MINOR PROJECT MODIFICATION

SAN FRANCISCO PUBLIC UTILITIES COMMISSION WATER SYSTEM IMPROVEMENT PROGRAM

Minor Project Modification Number: 001		Date: 5/16/11
Project Title:	Calaveras Dam Replacement Project	
MEA Case No./Project No.	2005.0161E/CUW37401	
MPM Prepared By:	Booker Holton, ECM	
MPM Triggered By:	<input type="checkbox"/> RFD <input type="checkbox"/> PCO <input checked="" type="checkbox"/> Other: SFPUC	
Landowner:	SFPUC	East Bay Regional Park District & Garcia Resident
Vegetative Cover/Land Use:	Landscaped, paved, gravel areas; bare soil, disturbed grassland	Net Acreage Affected: 0.005 acre (200 sq. ft.)
Modification to:	<input type="checkbox"/> Mitigation Measure:	<input checked="" type="checkbox"/> Other: Project Design
	<input type="checkbox"/> Permit:

Figure 2. CDRP- Minor Project Modification of Staging Area 6

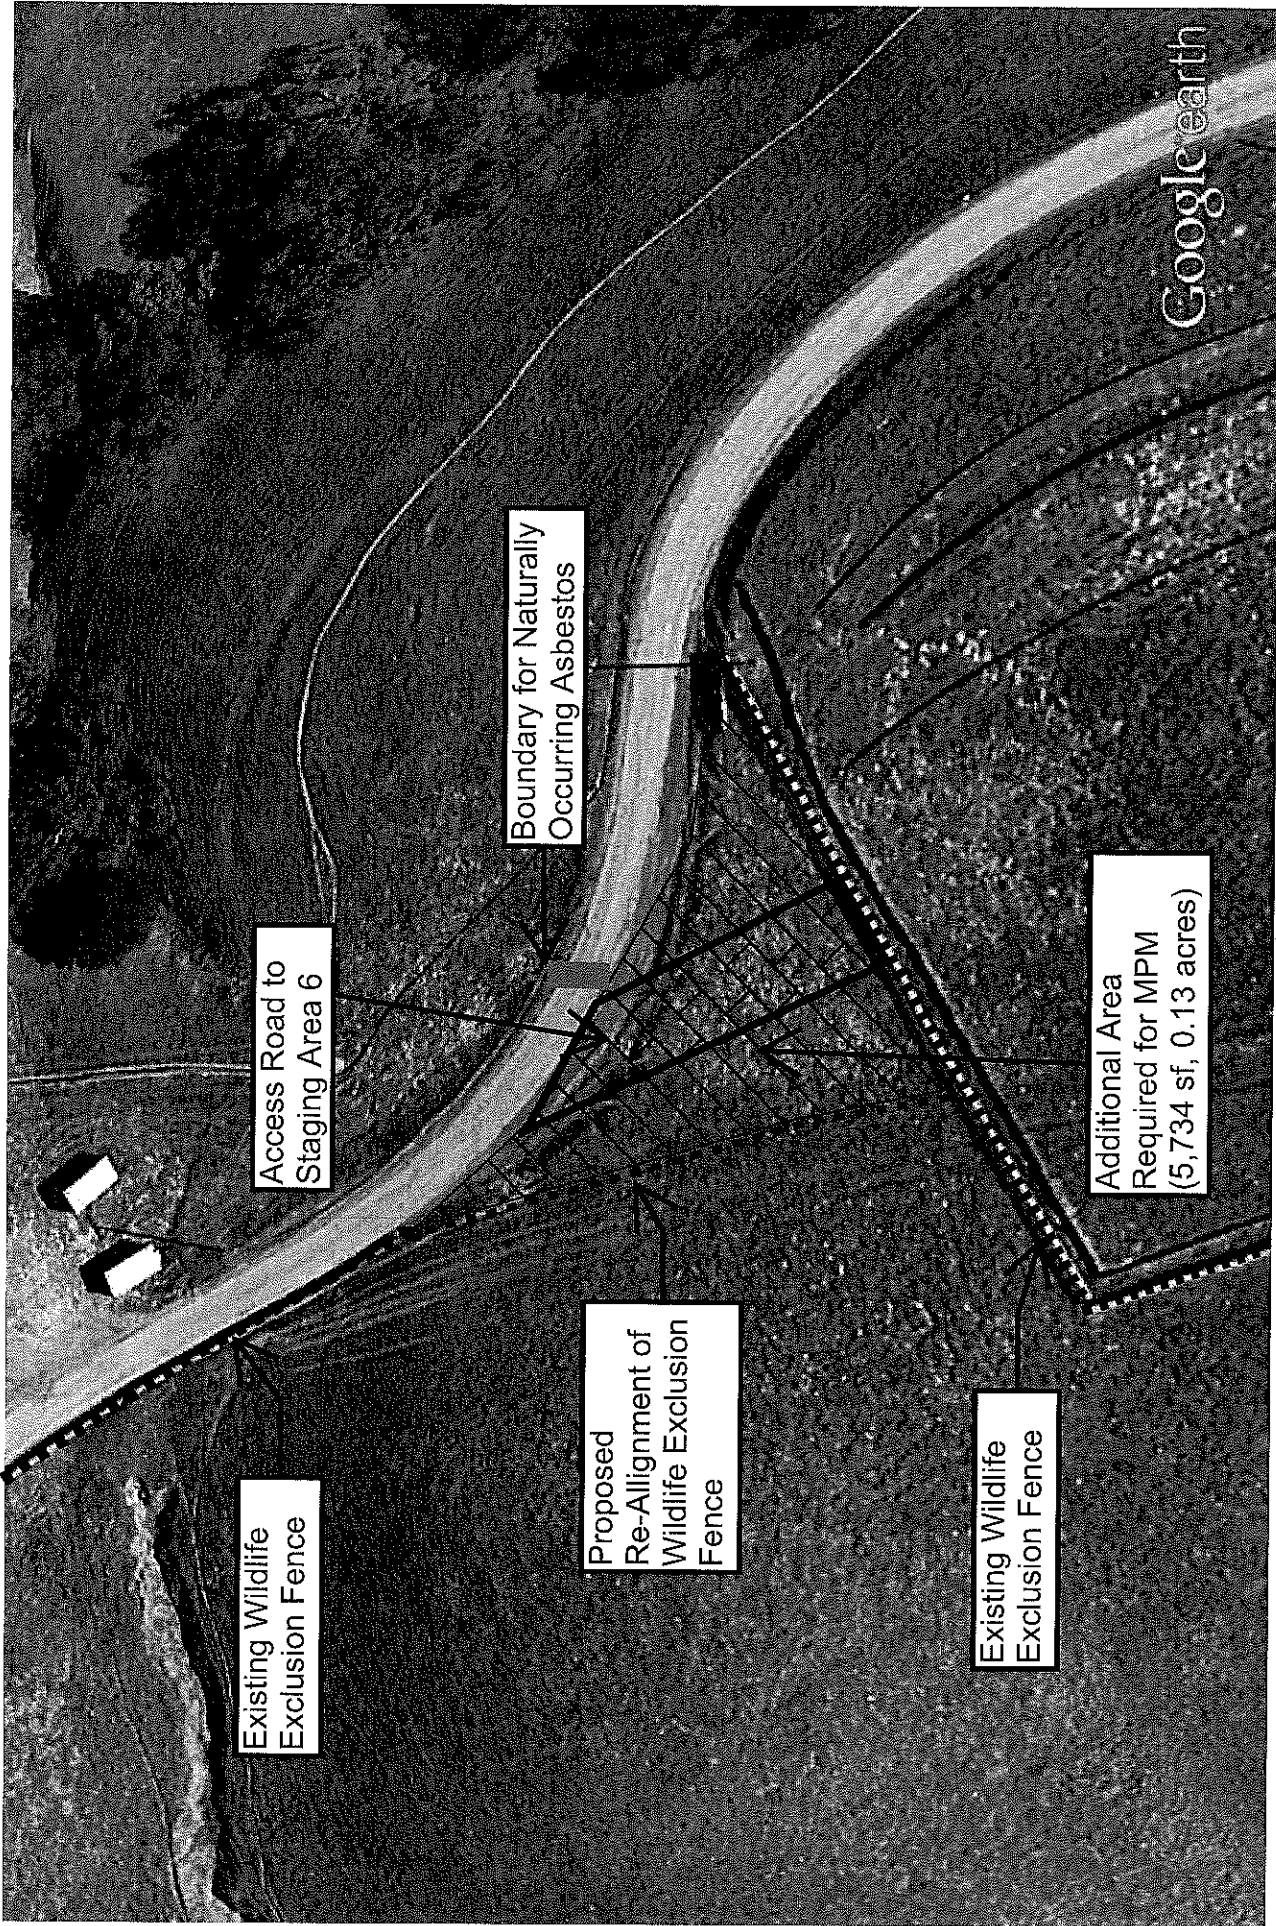
This modification would allow for an entrance on the north side of Staging Area 6 (Figure 2) and for workers to be picked up on the south side of the staging area by project transportation. This proposed new configuration would provide access to personal vehicles without having to traverse areas within the project that may contain naturally occurring asbestos, thereby reducing the potential for asbestos dust to migrate off site and impact construction workers and their families. The demarcation of naturally occurring asbestos is identified on Figure 2.

Figure 1. Like-for-Like Exchange of Project Footprint MPM 16

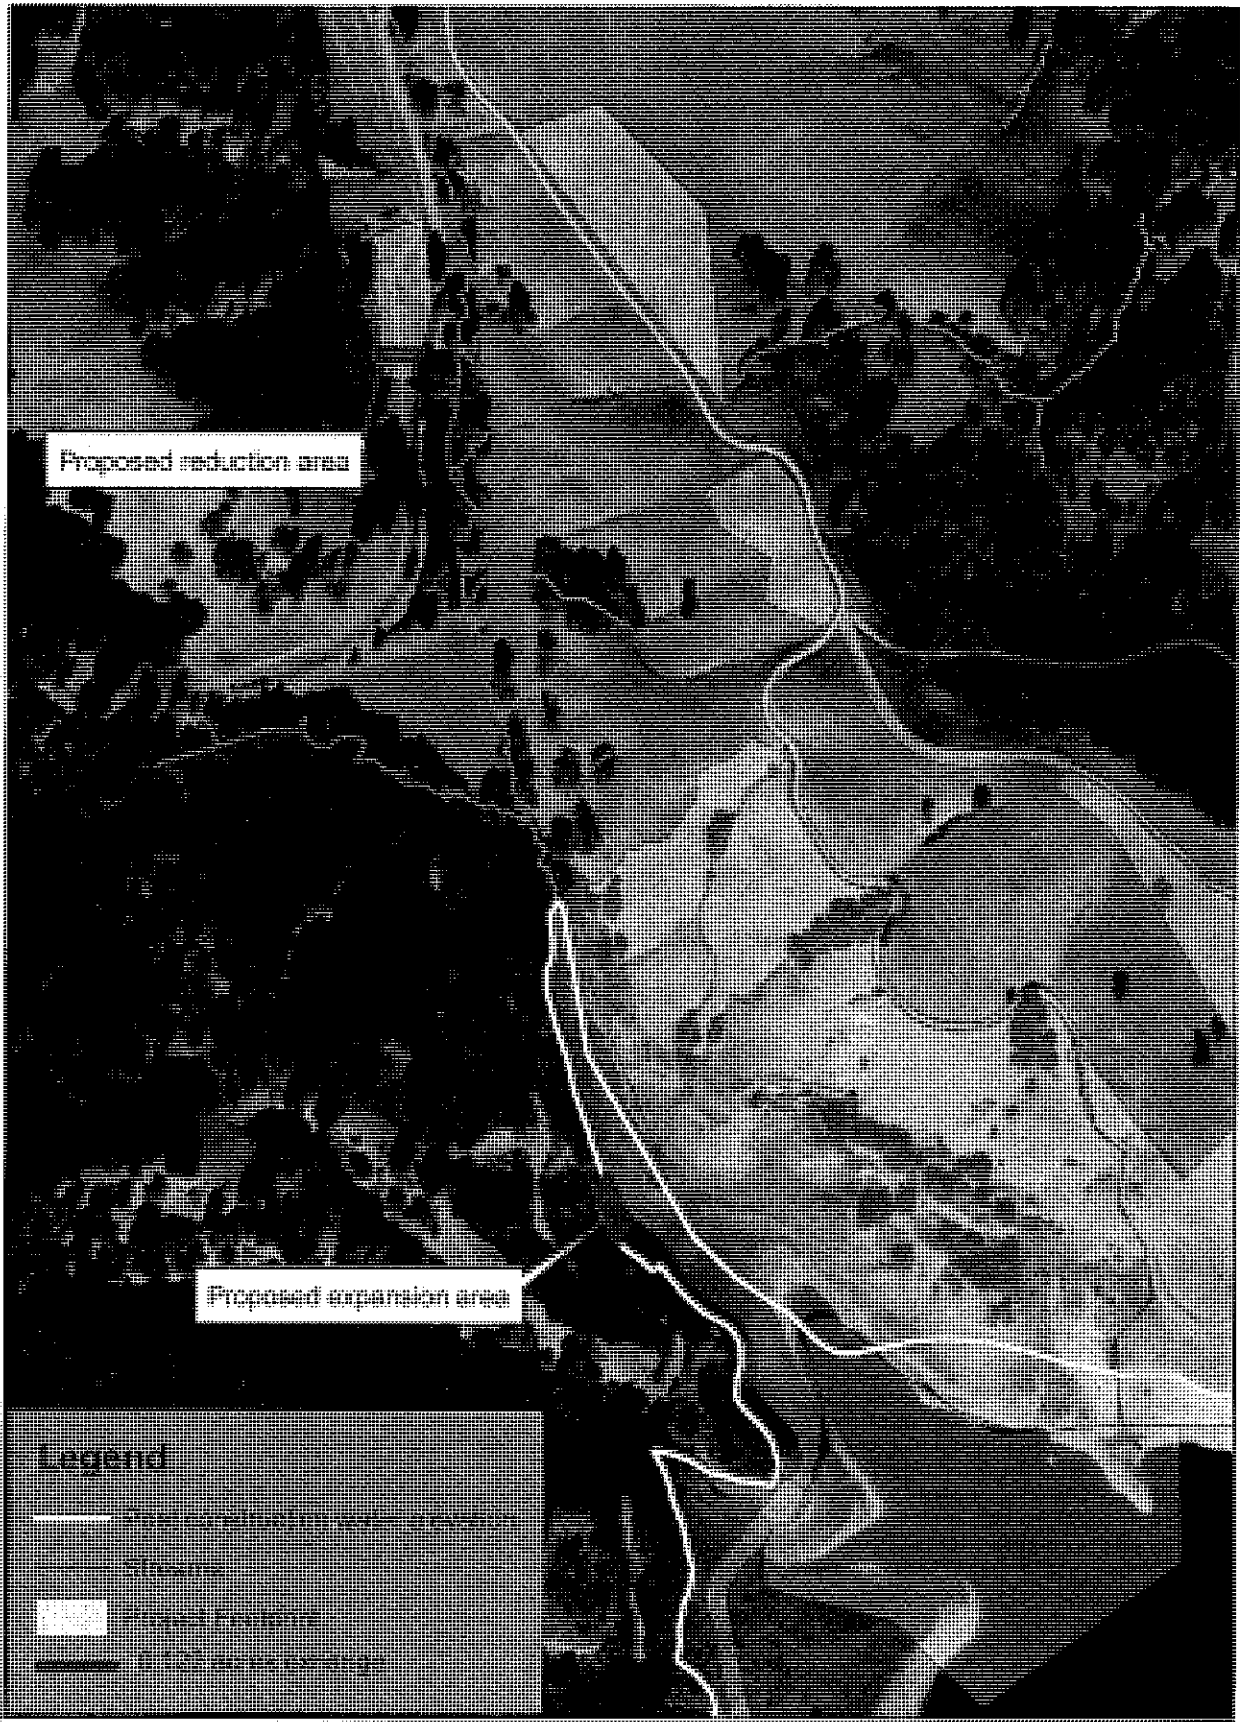
The proposed temporary trestle and temporary rock jetty will disturb approximately 0.25 acre (5,000 cubic yards) of the Reservoir (Figure 3), including approximately 43 square feet (approximately 33 cubic yards) for temporary steel piles. However, the contractor will reduce the area that would have been occupied by the barge haul route option by the same amount so that there is no net change in the total impacts to the reservoir (Figure 4). Therefore, there would be no net impact to reservoir within the project area from this MPM and the exchange of project footprint is "like-for-like" for acreage and temporary fill.
